Columbia Container Ltd. VFPA Projects Vancouver

BP Amendment Submission – June 16 2017

Re: CCL Transloading Facility Permit 13-123 - Rail Car Receiving Shed Revision - Staff Rooms

Re: CCL Transloading Facility Permit 13-123 - Rail Car Receiving Shed Revision - Winch Shelter

Revising Rail Shed for Workers Facilities

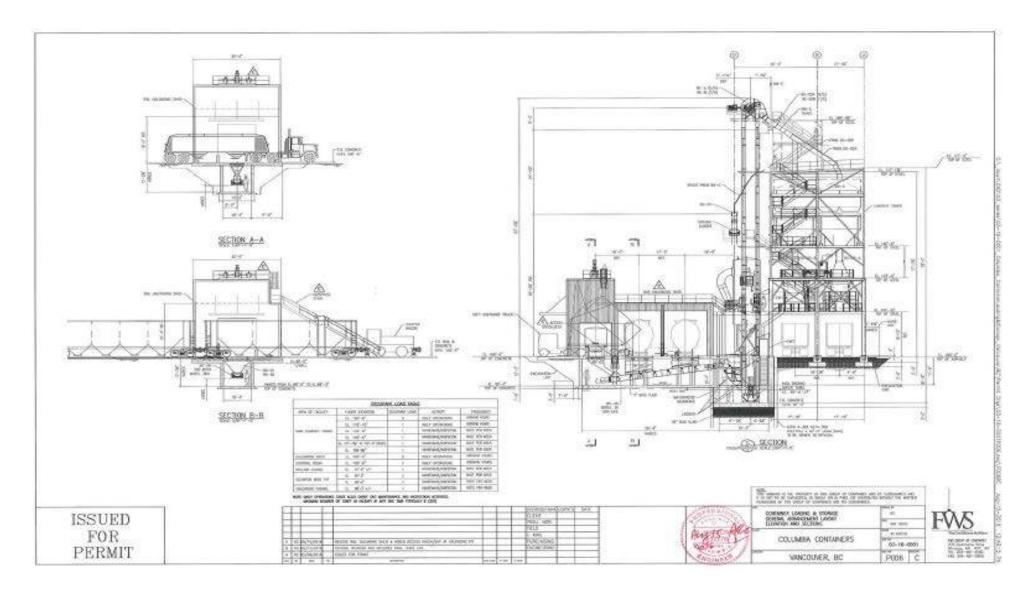
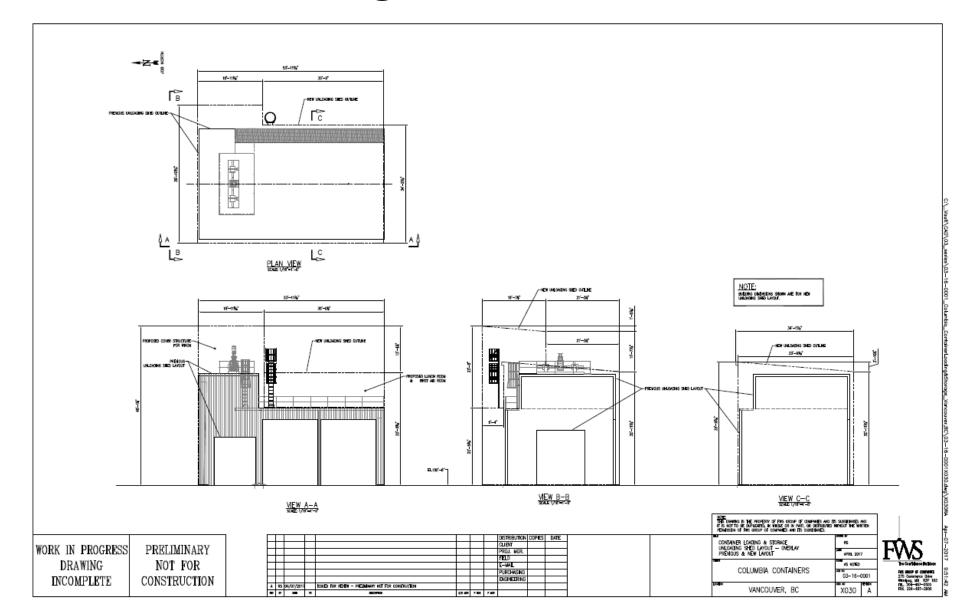
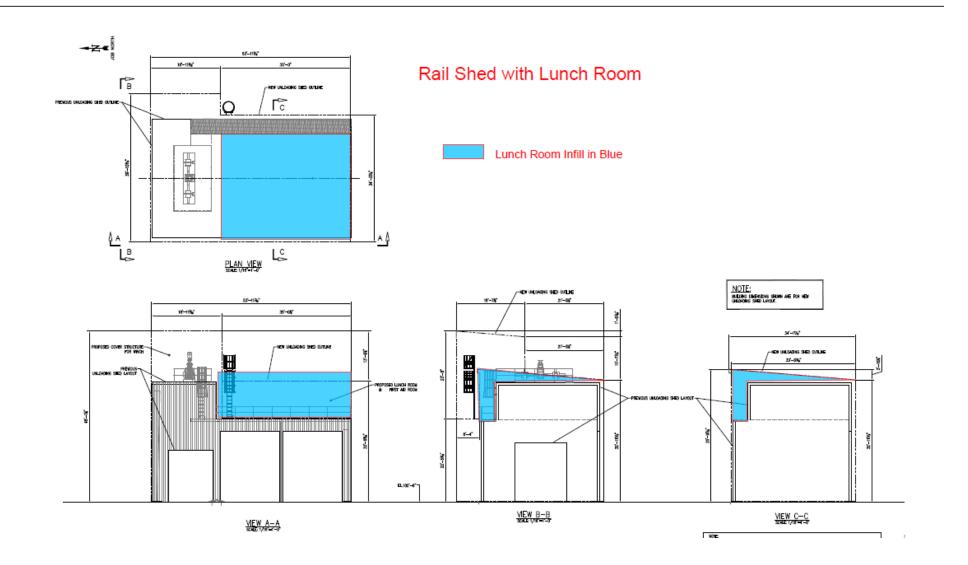
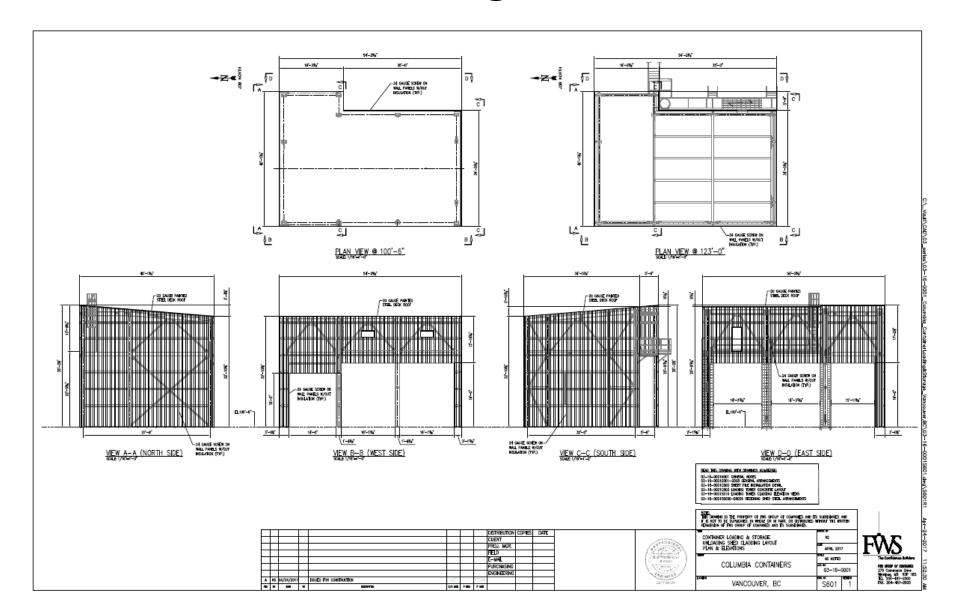
Columbia Containers Limited (CCL) wishes to amend its new Transloading Facility rail car receiving building to include for employee support rooms on a second floor. These spaces will include first aid, men's and women's locker rooms, funch room, and an office.

Employee support spaces are required for the new Transloading facilities. The current support spaces such as first aid, lunch room, and change rooms, are housed in modular offices located along the south lease line. These modular offices are planned to be removed upon completion of the new Transloading facility. CCLs plan was to construct a new free standing facility on grade on the north side of the new plant to replace these support spaces.

The proposed location, on top of the rail car receiving shed, is a significantly smaller area but solves all of the concerns listed above. The new location will better serve the employee, be significantly safer and free up valuable yard space.

Winch Cover Addition

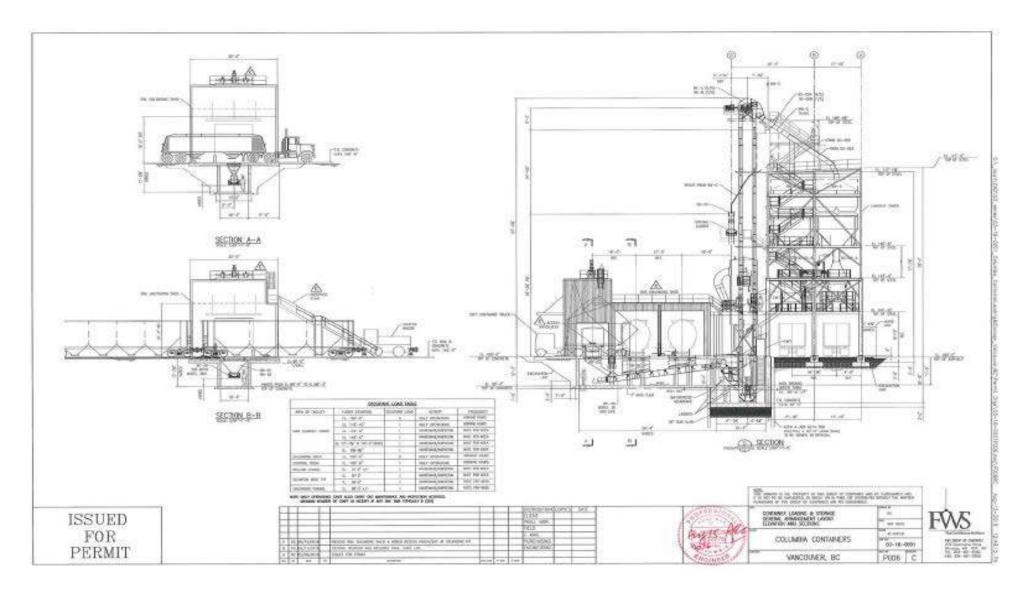
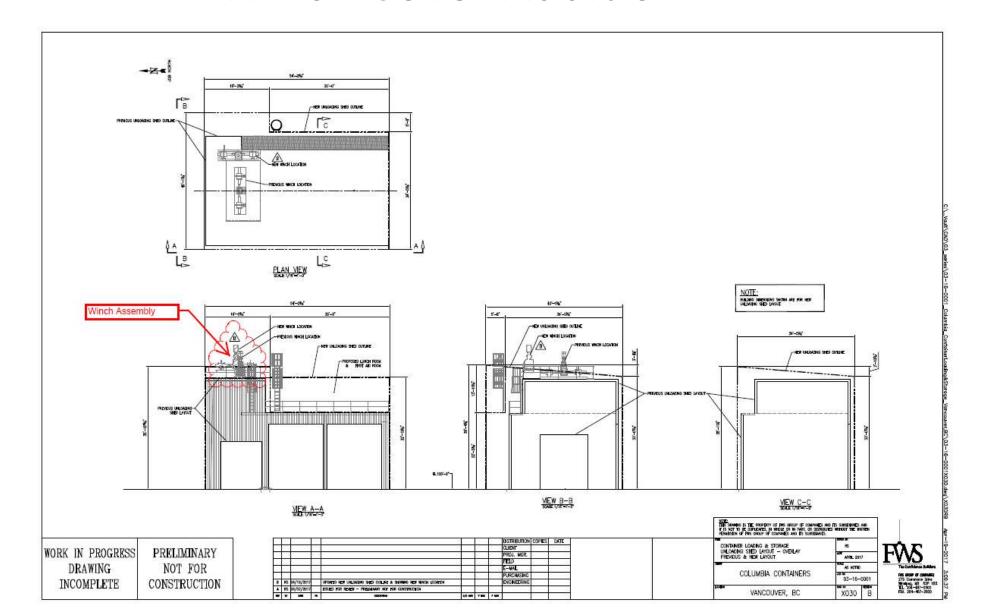
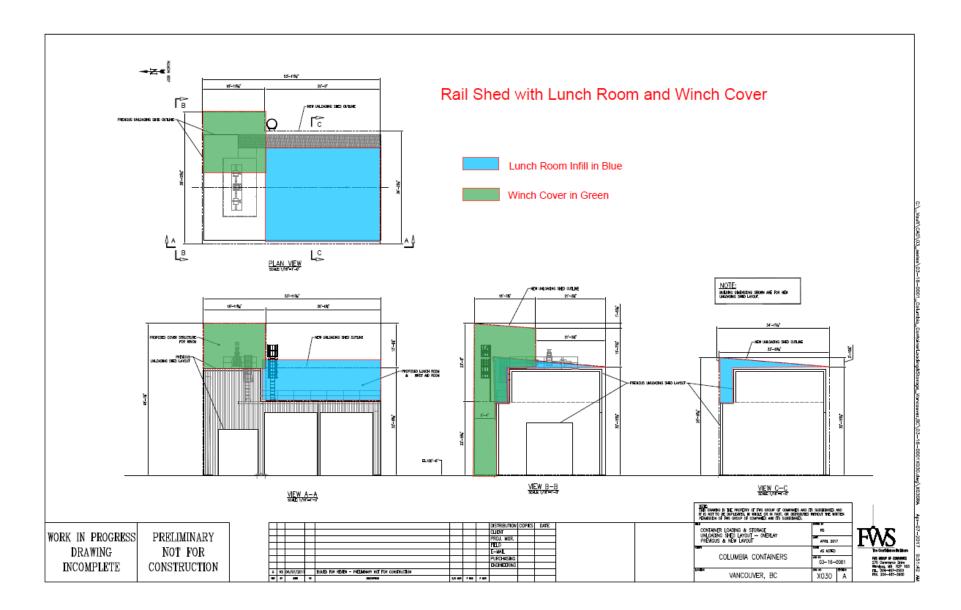
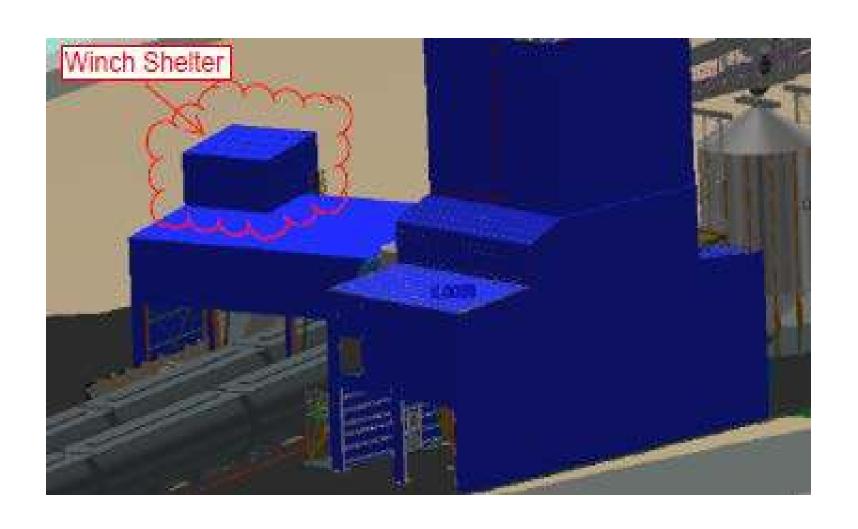
Columbia Containers: Limited (CCL) wishes to amend its new Transloading Facility rail car receiving building to include a winch shelter on the far north end. The winch cover is required to protect equipment from weather and provide an area for maintenance.

A shelter is required and is designed to protect the winch assembly and roof penetrations from weather. The shelter also needs to house the workers safely at this elevated location
